593 & 601-603 Laurier Avenue West

UDRP REPORT
Official Plan and Zoning By-law Amendment Applications
June 15, 2025

URBAN DESIGN BRIEF

Response to UDRP Comments

601 LAURIER AVENUE PROJECT MASSING / MICROCLIMATE CONDITIONS OF THE SITE

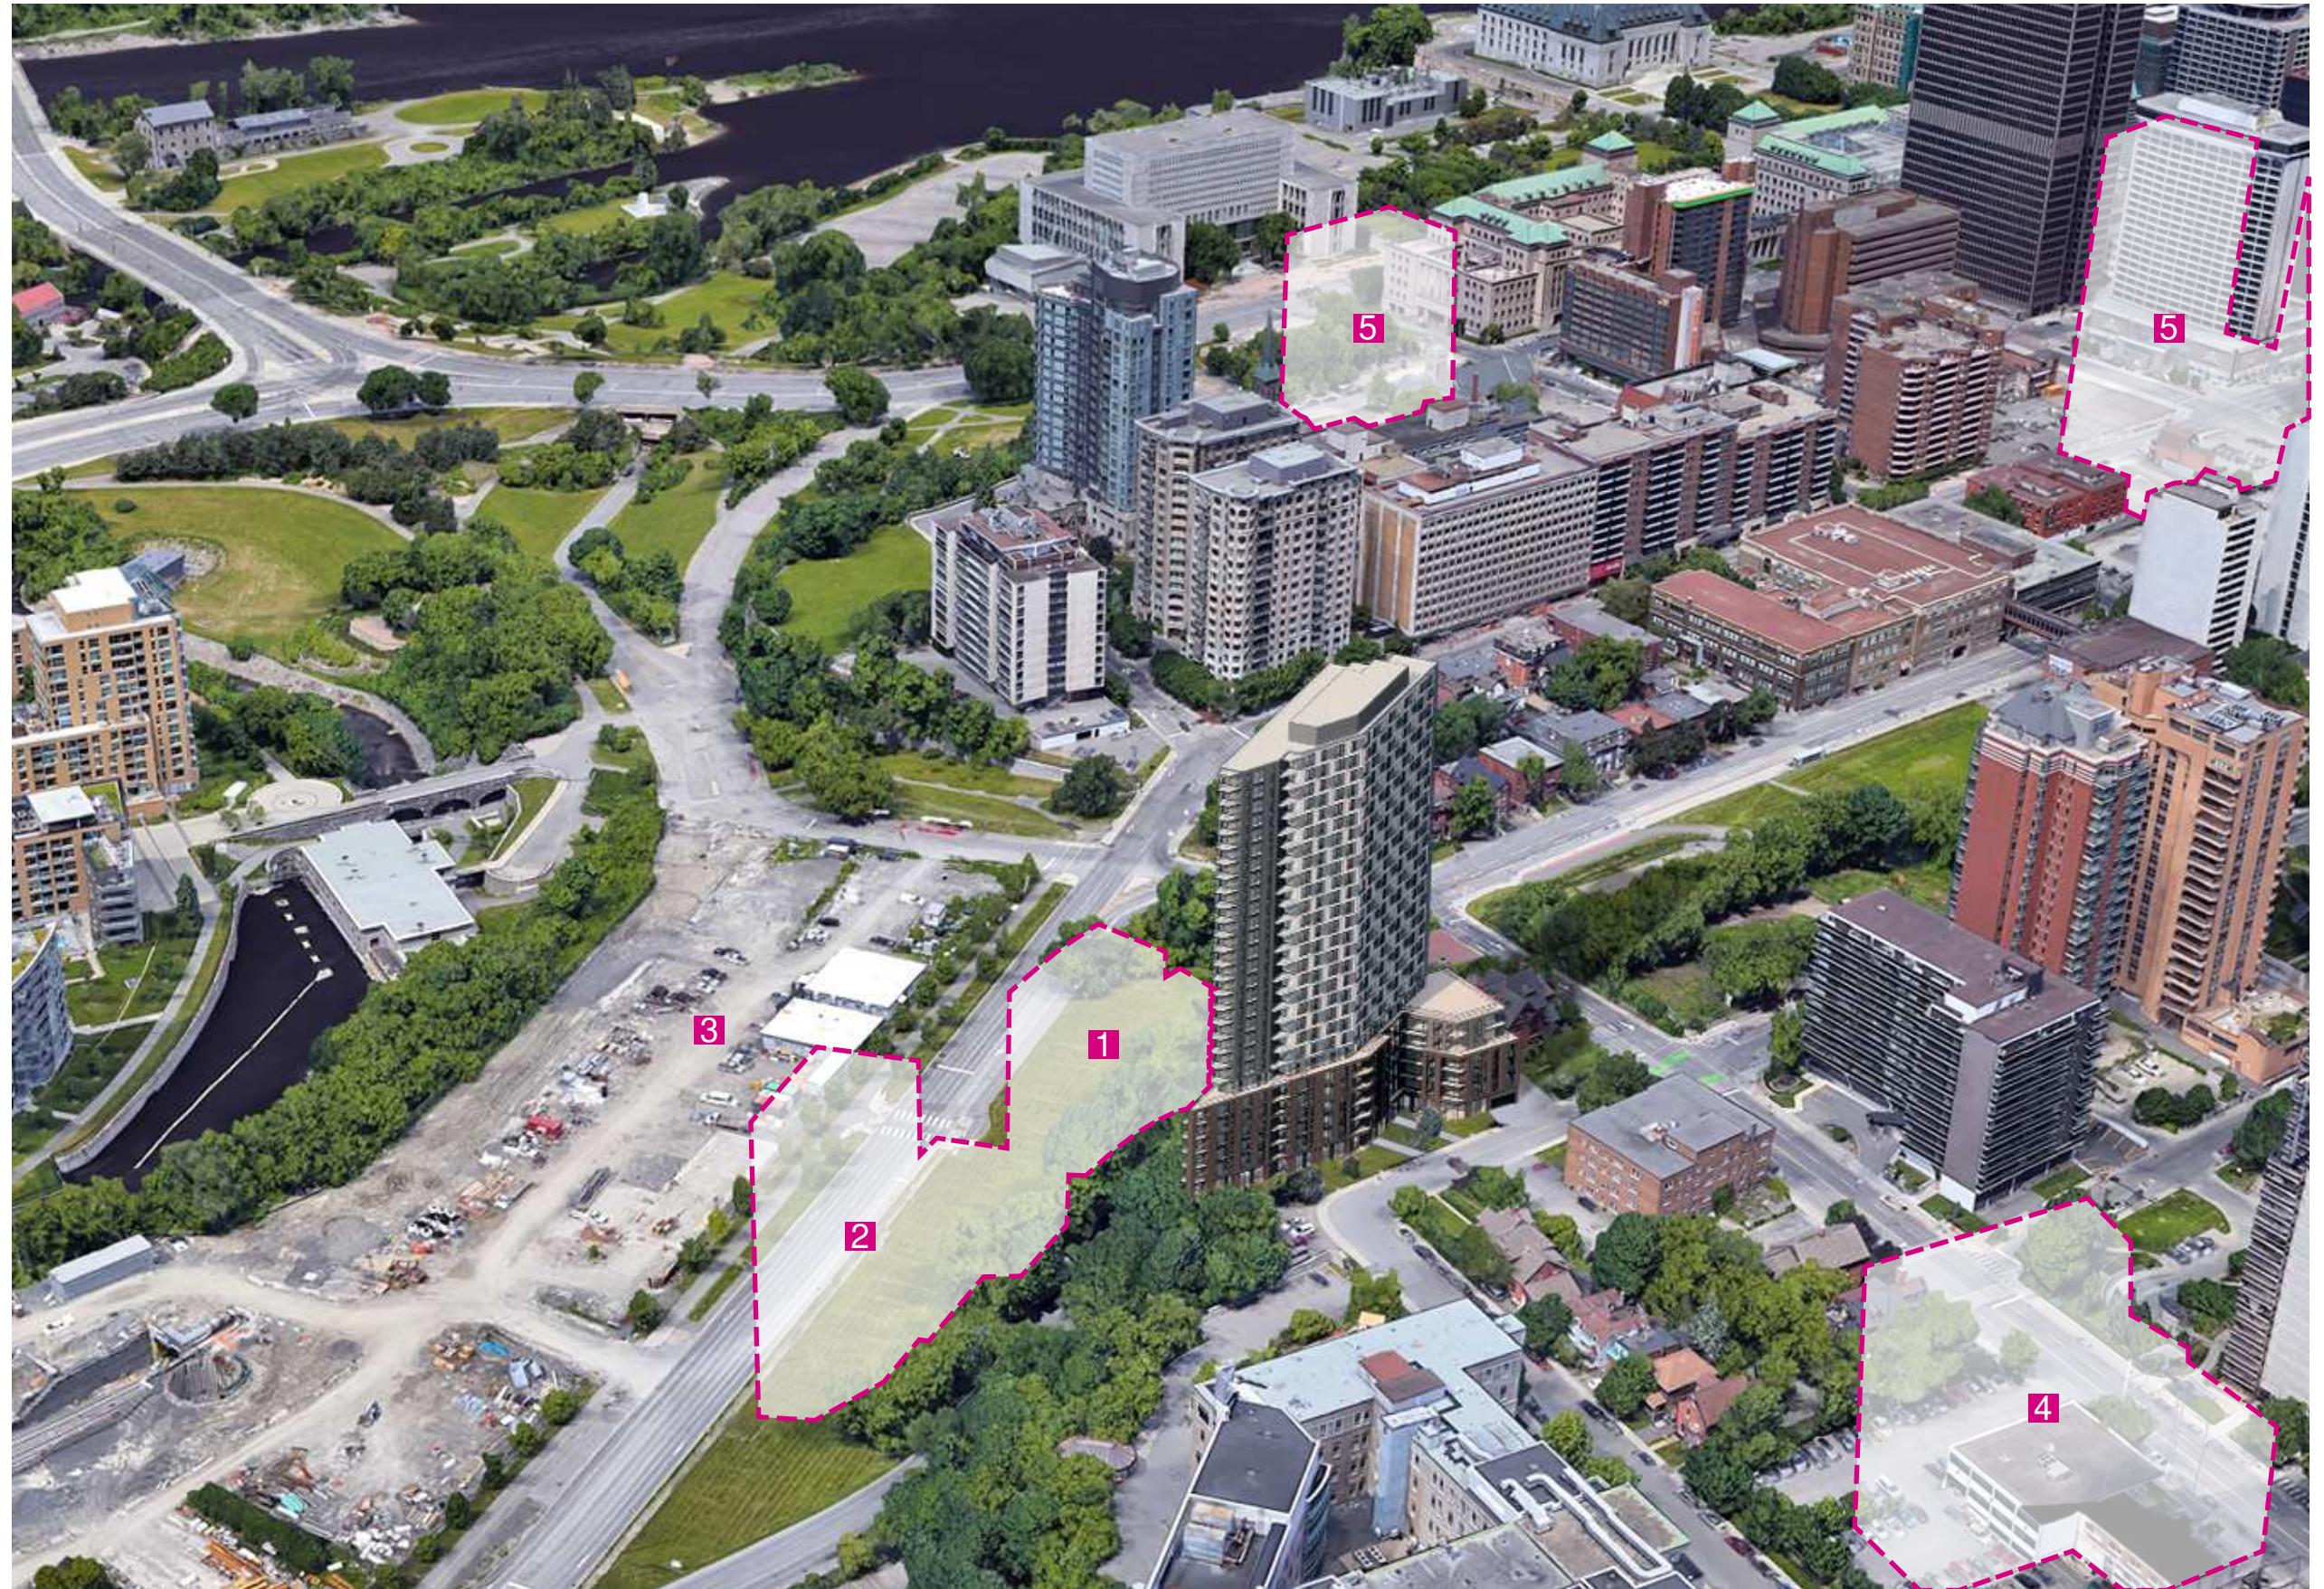
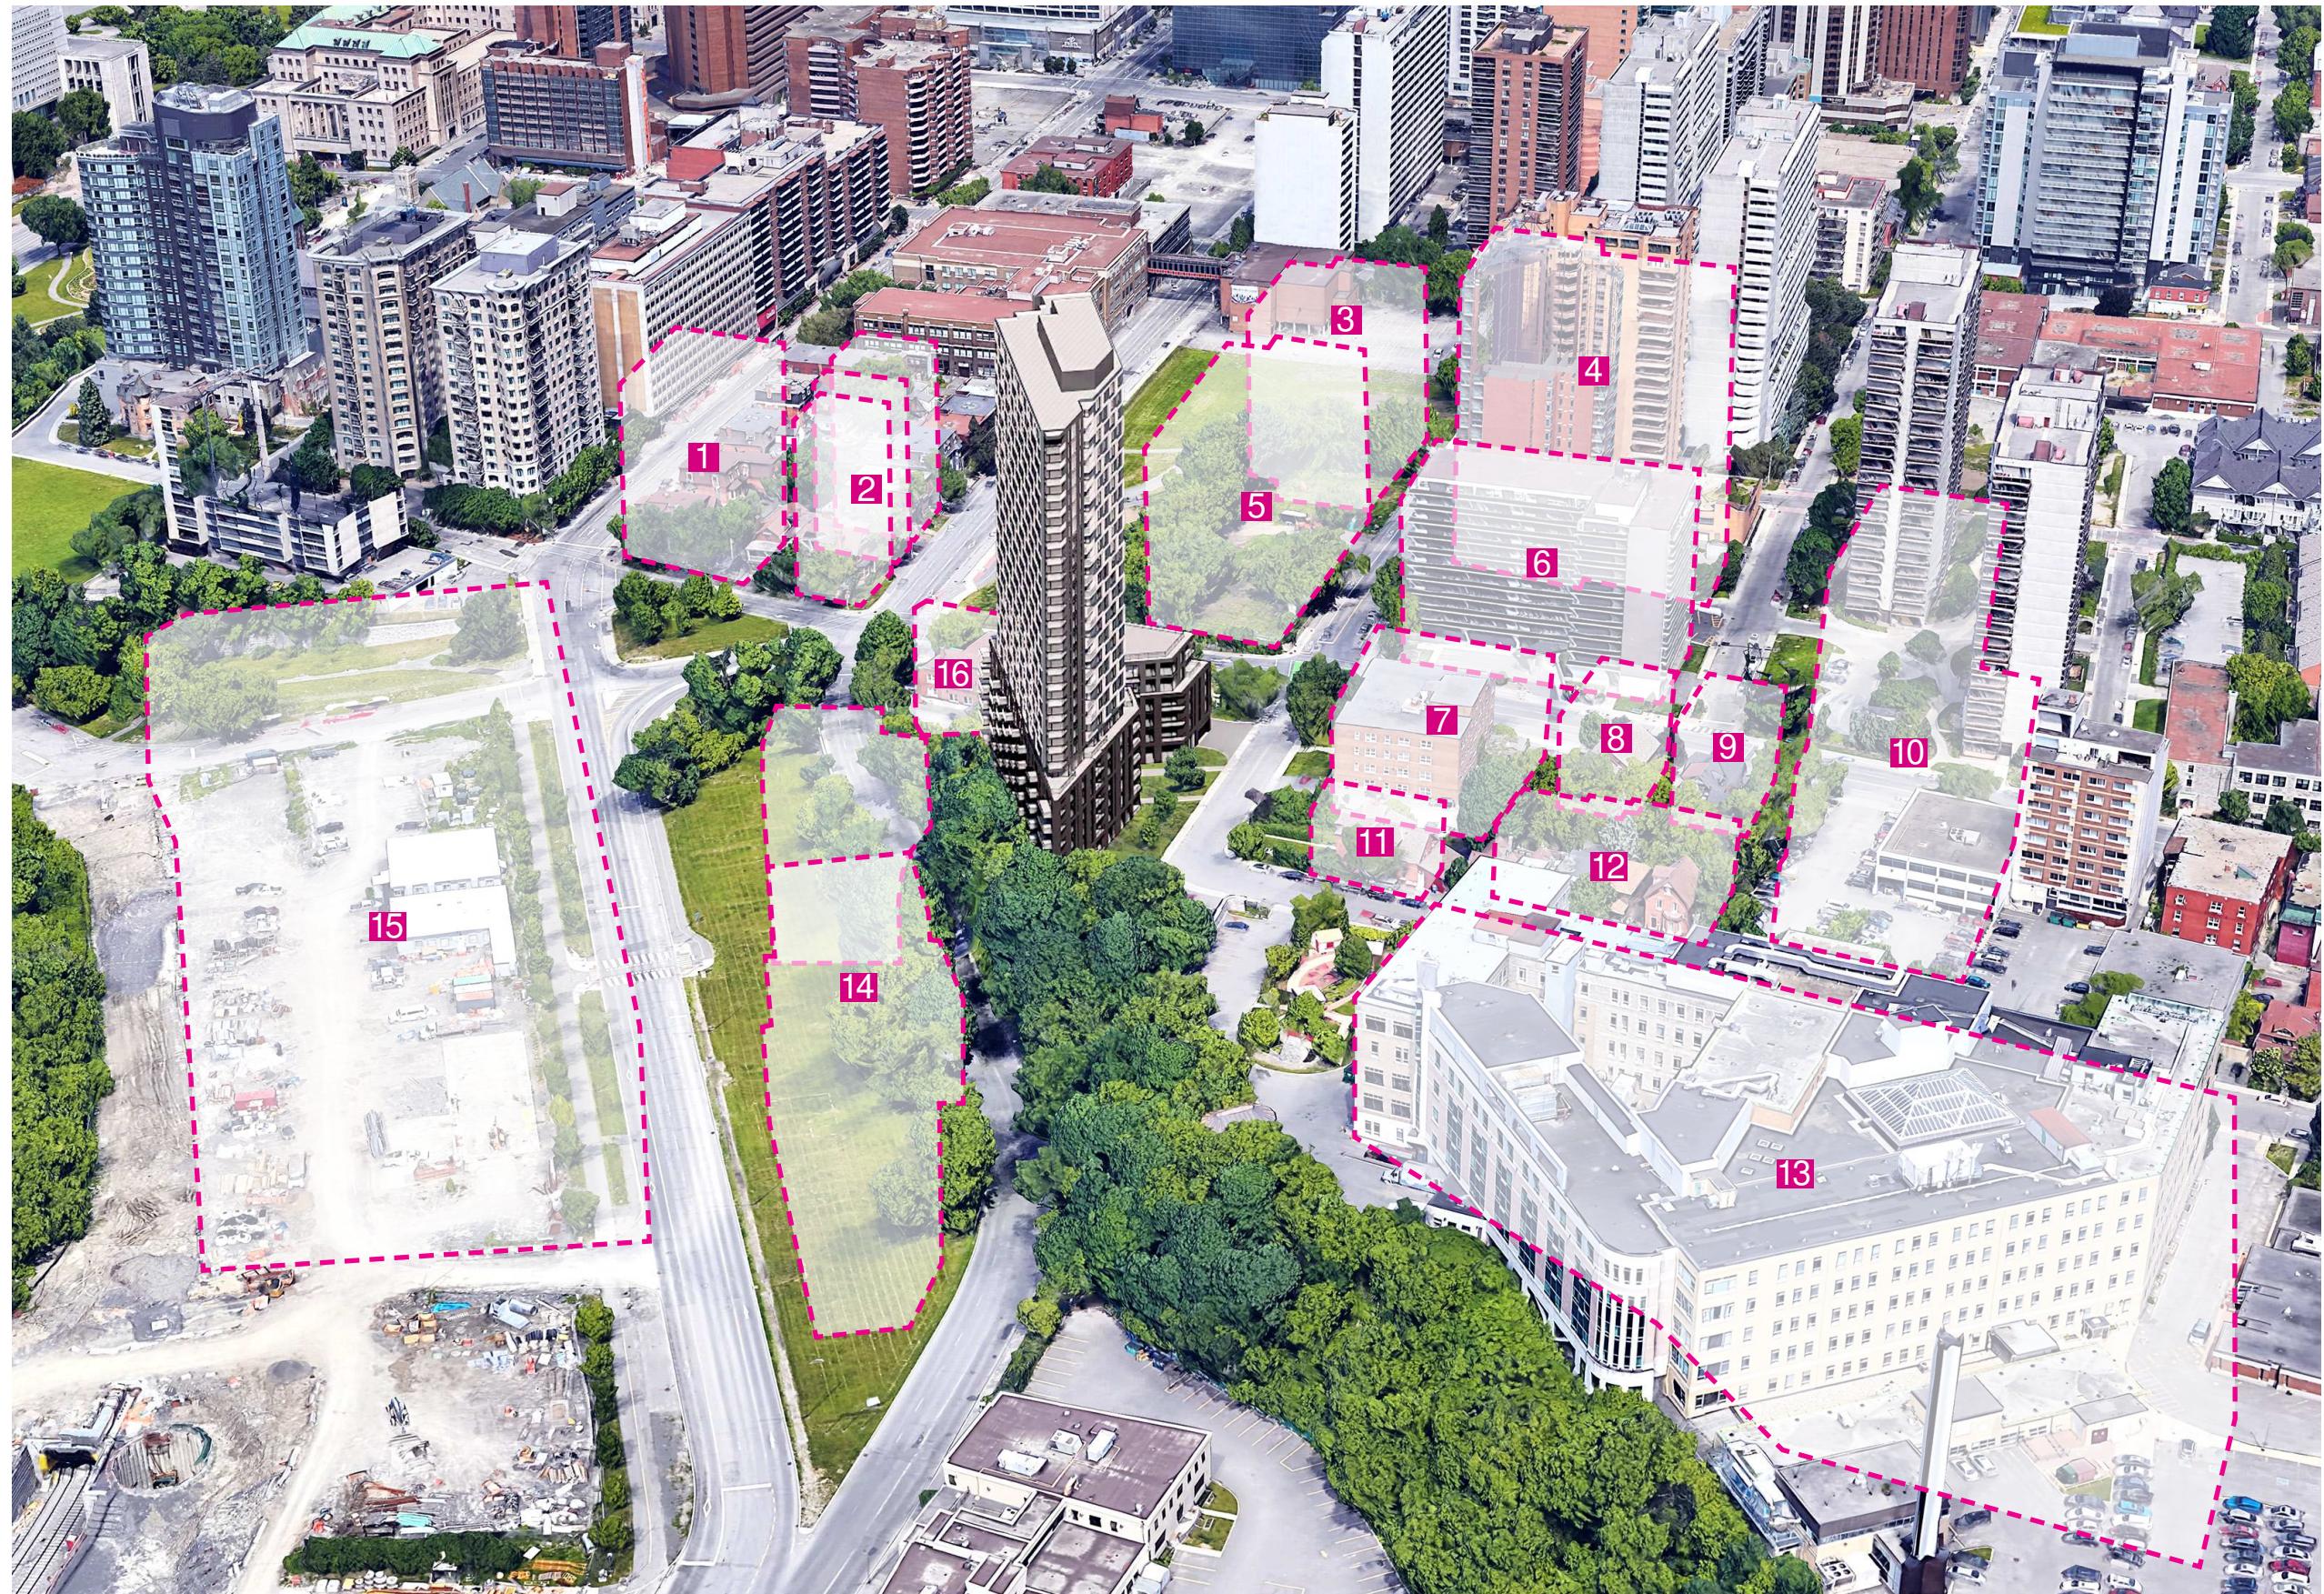
We recommend providing massing of the project and its context to better understand the future relationship to the existing context of the surrounding properties and their planned context. Be sure to include the properties down the escarpment and along Cambridge, Laurier, Bronson and where Slater has been removed.

We have provided material illustrating the massing of the project and its context, showing the relationships with the escarpment and surrounding properties. This includes properties down the escarpment and along Cambridge, Laurier, Bronson, and the area where Slater has been removed. These visuals help to better understand the future relationship to the existing and planned context of the surrounding area.

601 LAURIER AVENUE TRANSITION / ANGULAR PLANE STUDY

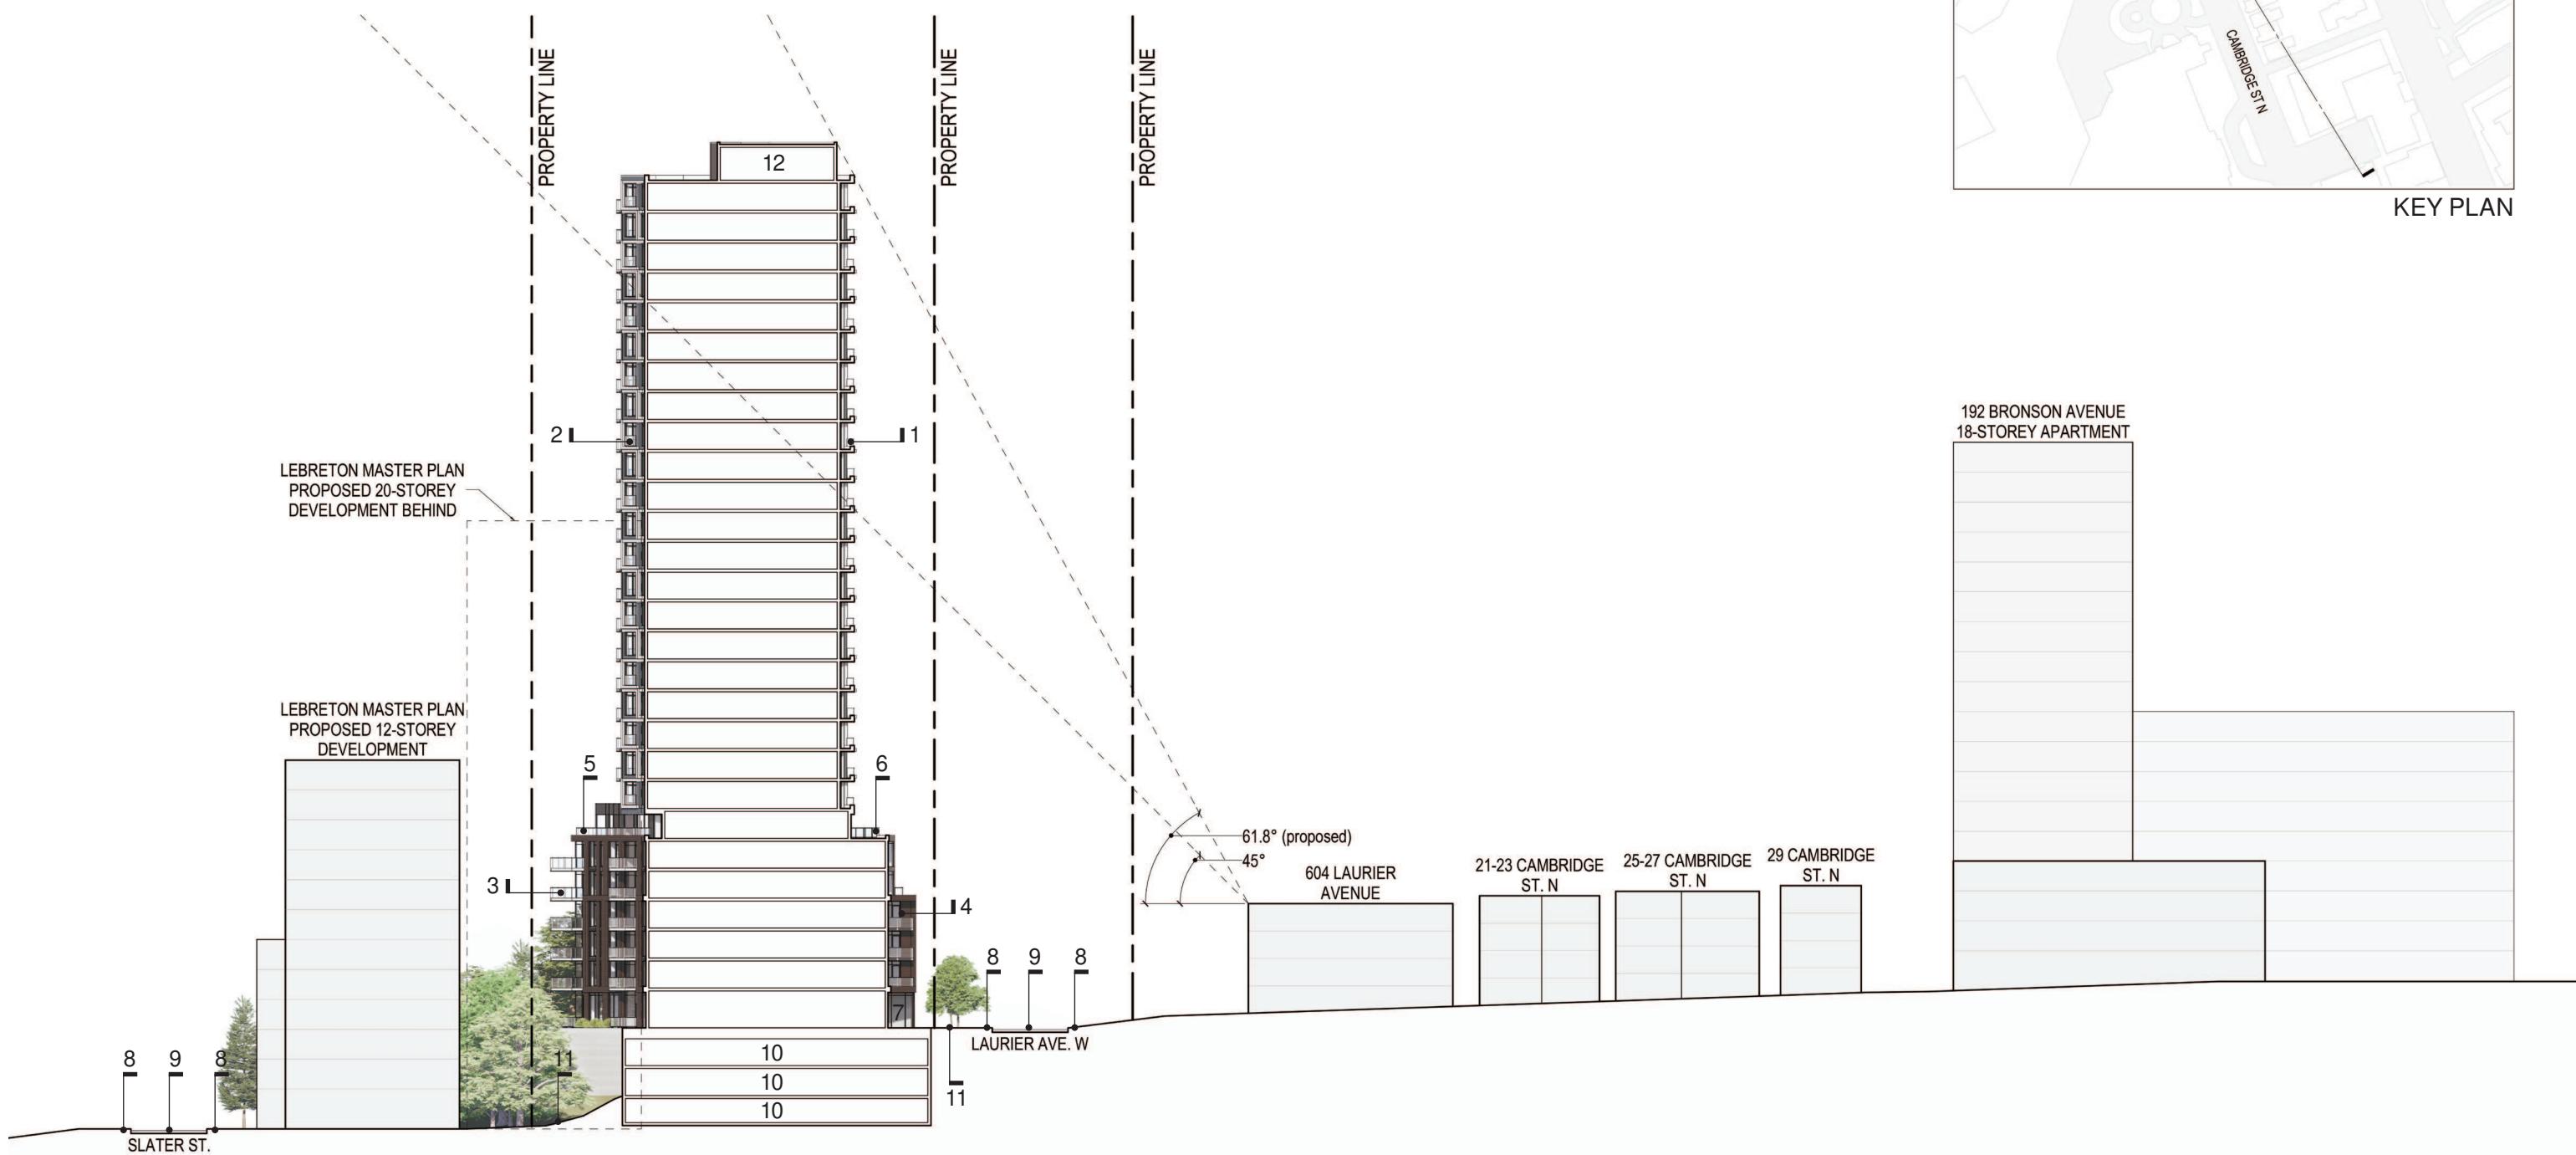
Height: There would be two overlapping tools to determine the best approach to analysing appropriate height being the NCC Parliamentary view shed analysis, extrapolated over the site, and a 45-degree angular plane drawn from the residential properties to the south on Cambridge. We recommend illustrating both and providing a rationale for the approach preferred.

We have provided graphic material illustrating the building's relationship with the neighboring buildings, including the 45-degree angular plane calculated from the existing buildings along Cambridge to the south. Our subject property falls outside the boundaries of the NCC Parliamentary view sheds, so this analysis was not considered.
